STATE OF CONNECTICUT  
CONNECTICUT SITING COUNCIL

APPLICATION OF NEW CINGULAR WIRELESS  
PCS, LLC (AT&T) FOR A CERTIFICATE OF  
ENVIRONMENTAL COMPATIBILITY AND  
PUBLIC NEED FOR THE CONSTRUCTION,  
MAINTENANCE AND OPERATION OF A  
TELECOMMUNICATIONS TOWER FACILITY  
LOCATED AT 95 BALANCE ROCK ROAD IN THE  
TOWN OF HARTLAND, CONNECTICUT

DOCKET NO. 408

**NEW CINGULAR WIRELESS PCS, LLC ("AT&T")  
RESPONSES TO SITING COUNCIL INTERROGATORIES (SET TWO)**

# **EXHIBIT A**

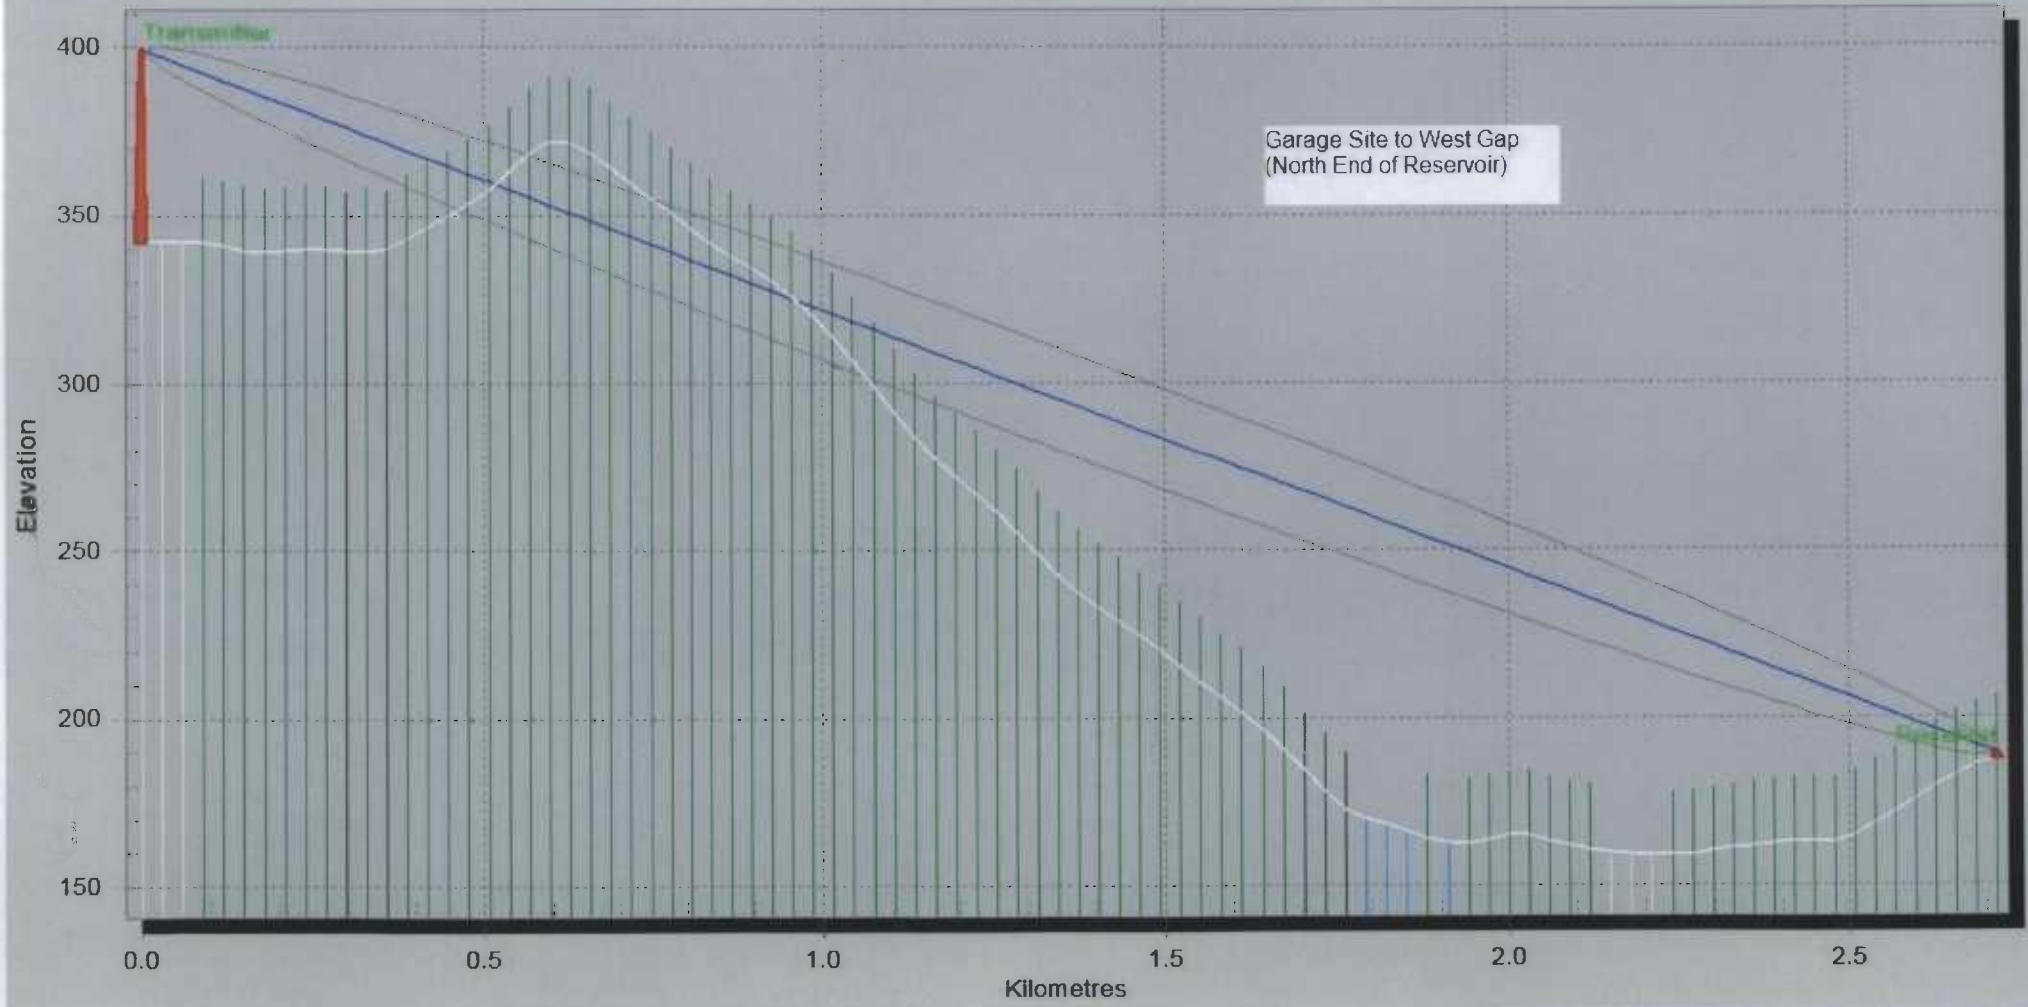
Q1. Is the property listed as No. 8 in the Site Search summary owned by the DEP or DOT? Why was this site rejected by radiofrequency engineers? Please describe topographic features that may be preventing adequate coverage to the proposed service area.

AT&T's RF engineers determined that a tower facility at the garage site would not provide reliable service to meet the coverage objectives for this area. See Response No.9 and propagation map in Exhibit E of AT&T's Responses to Siting Council Interrogatories (AT&T's Exhibit No. 3). Attached in Exhibit A are terrain profiles which demonstrate that the topography would block signal from a facility at this location.
